FORMERLY KNOWN AS:  
 **McMILLAN**

## PUD APPLICATION

### PARCEL 4 GROCERY / MULTIFAMILY BUILDING

PARCEL 4 - ZONING TABULATIONS WITH PROPOSED CHANGES

GROUND FLOOR PLAN

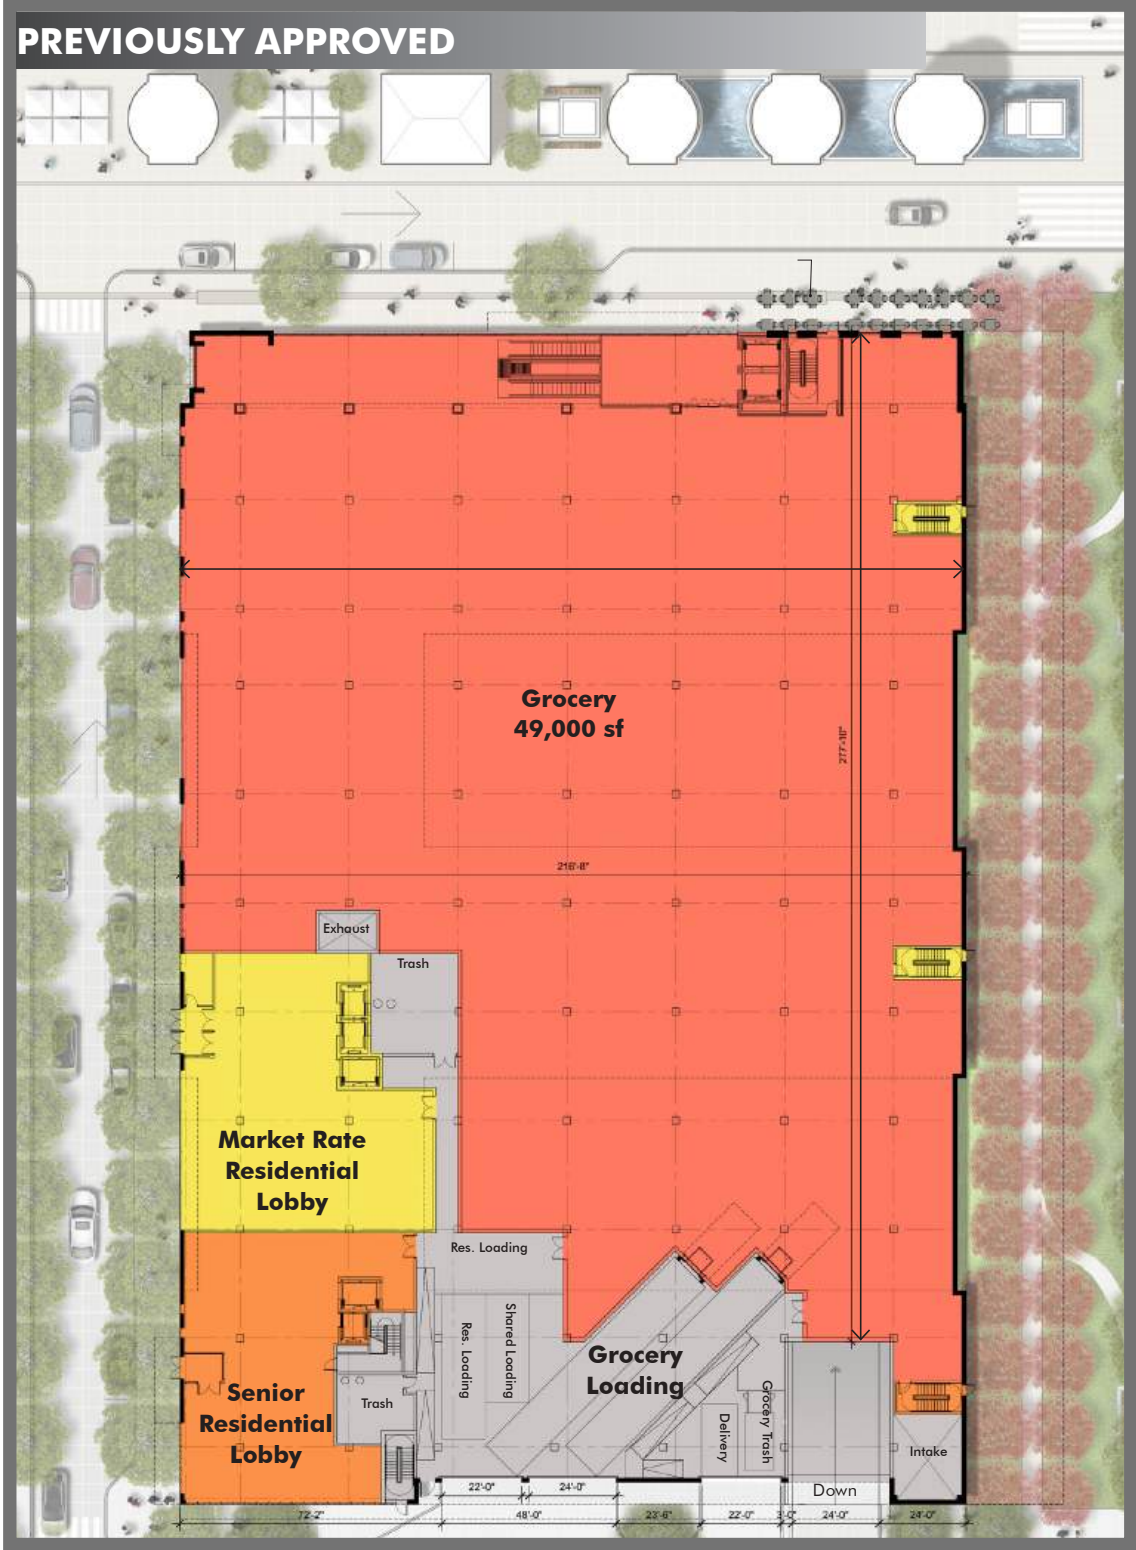
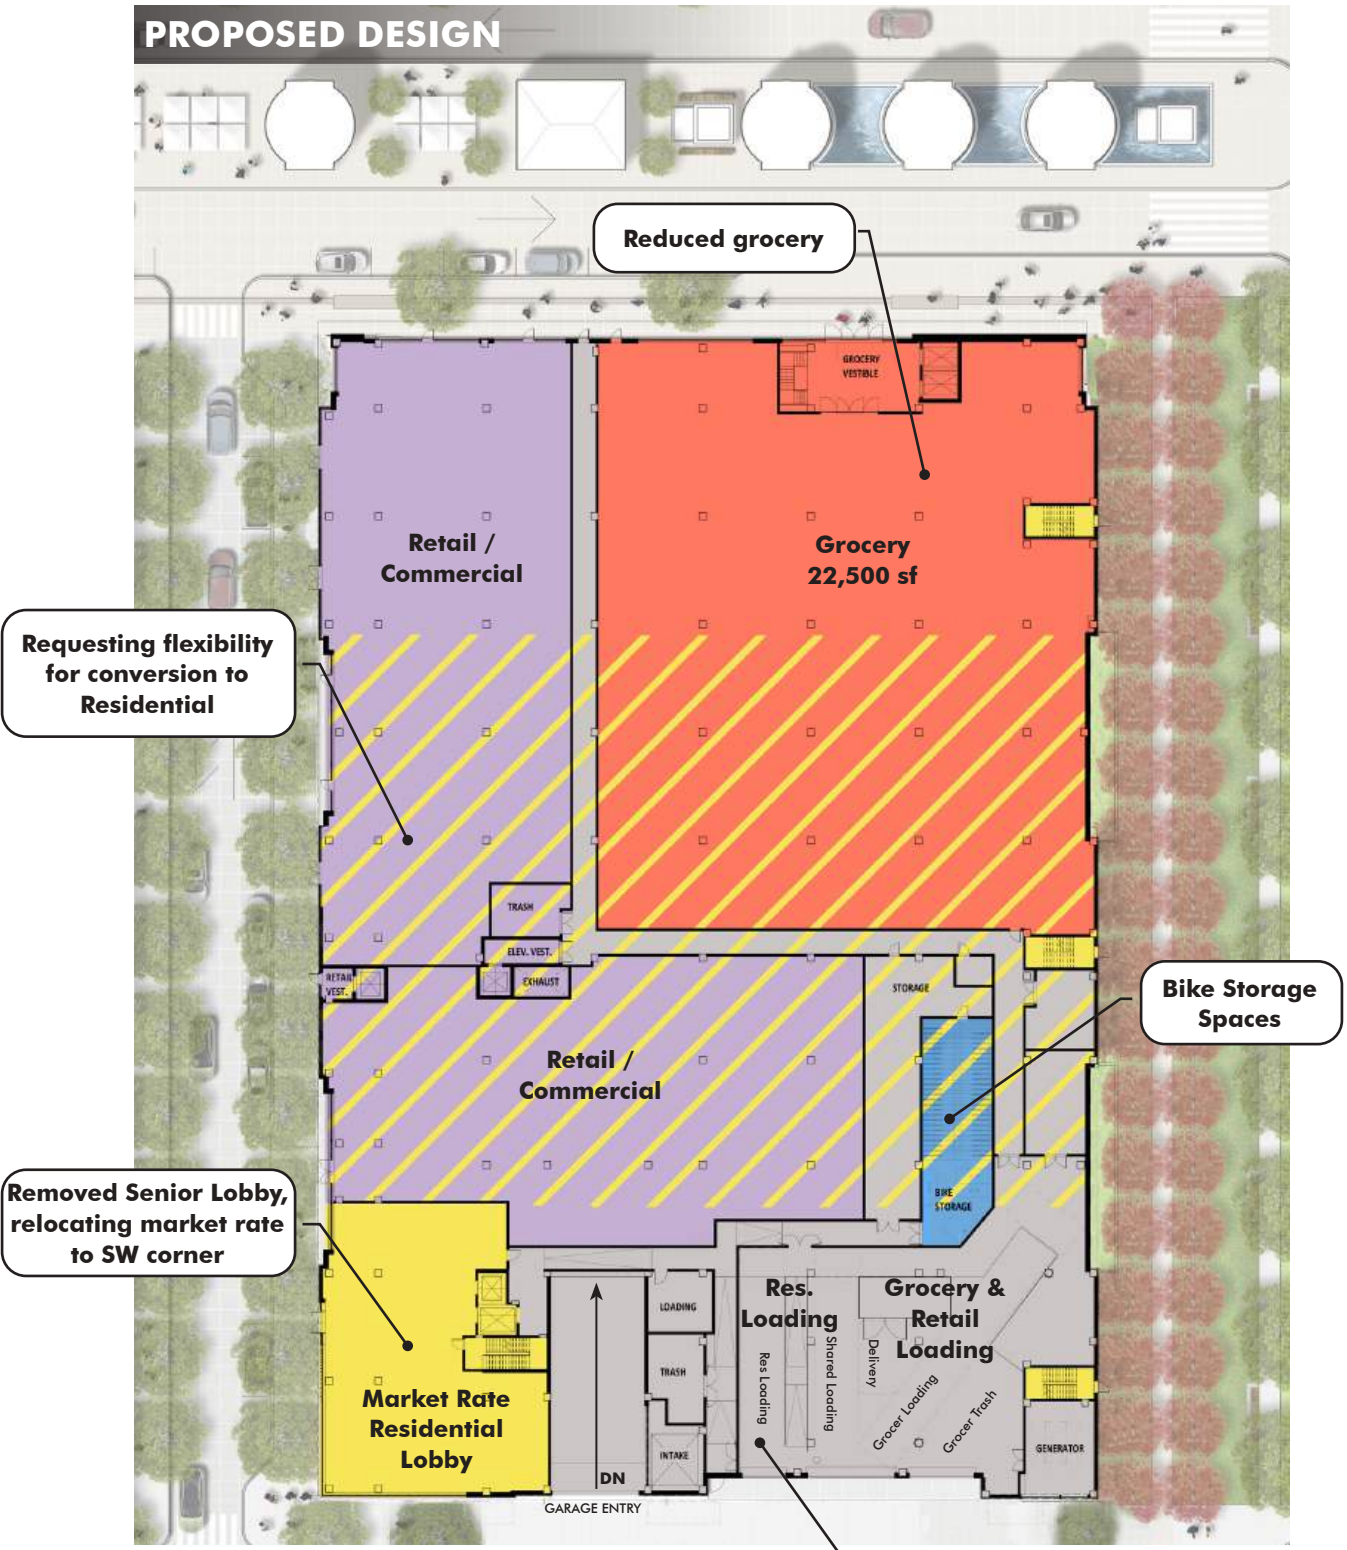
Garage Footprint Reduced

MATERIALS - PROPOSED ALTERNATES

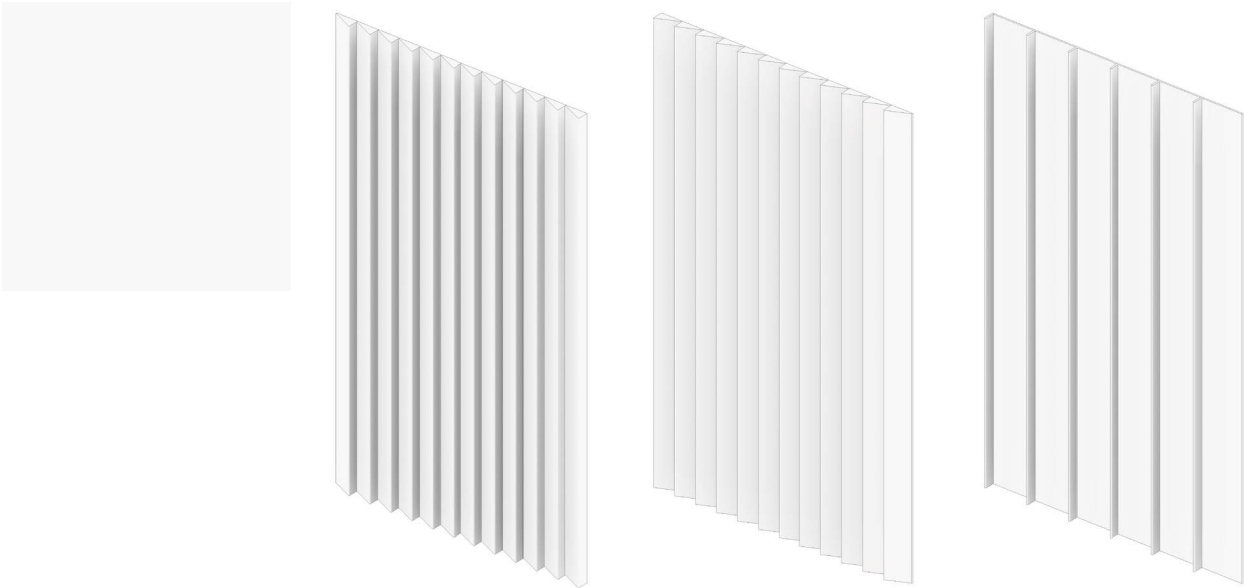
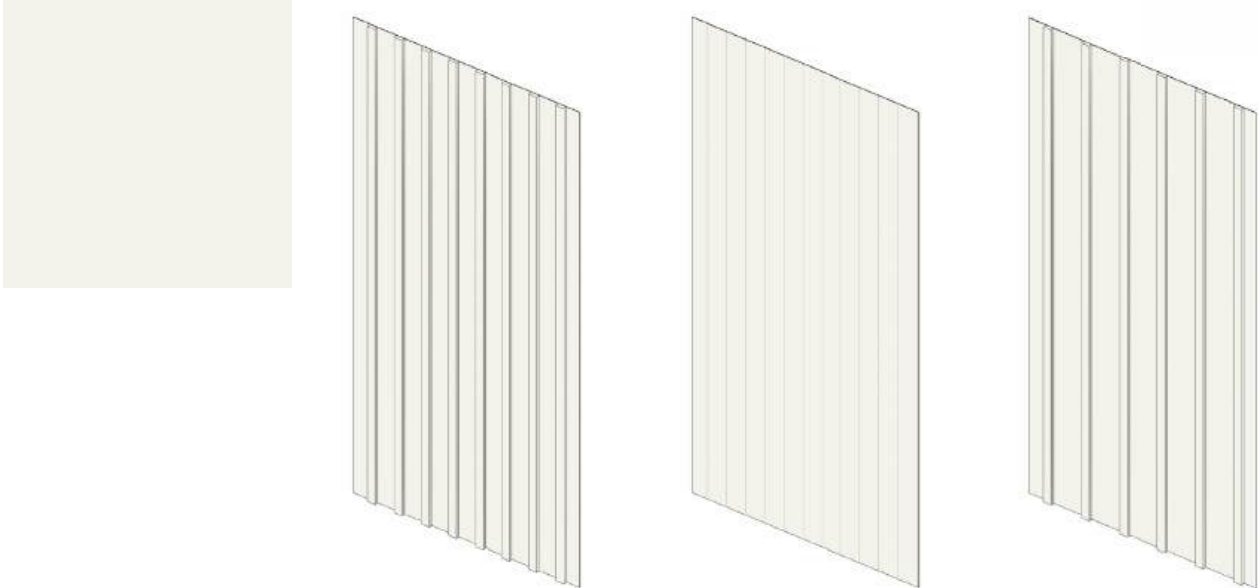
- 01 **WHITE METAL FACADE SYSTEM**  
proposed alternate: FIBER CEMENT FACADE SYSTEM
- 02 **CHARCOAL-COLORED METAL PANEL**  
proposed alternate: CHARCOAL-COLORED FIBER CEMENT FACADE SYSTEM
- 03 **LIMESTONE**  
proposed alternates: CAST STONE, MASONRY UNITS
- 04 **ALUMINUM / PVC FRAME WINDOW**  
proposed alternate: VINYL FRAME WINDOW
- 05 **ALUMINUM STOREFRONT SYSTEM**  
no proposed alternate
- 06 **PHENOLIC PANEL (TENANT SPECIFIC)**  
proposed alternate: TENANT ACCENT MATERIAL - TBD
- 07 **GRANITE BASE**  
proposed alternates: BRICK
- 08 **WOOD OR ALUMINUM WITH WOOD TEXTURE - PROVIDED NEAR RESIDENTIAL LOBBY**  
no proposed alternate
- 09 **BRICK - PROVIDED NEAR LOADING DOCK**  
no proposed alternate
- 10 **GLASS BALCONY RAILING SYSTEM**  
proposed alternate: METAL RAILING SYSTEM
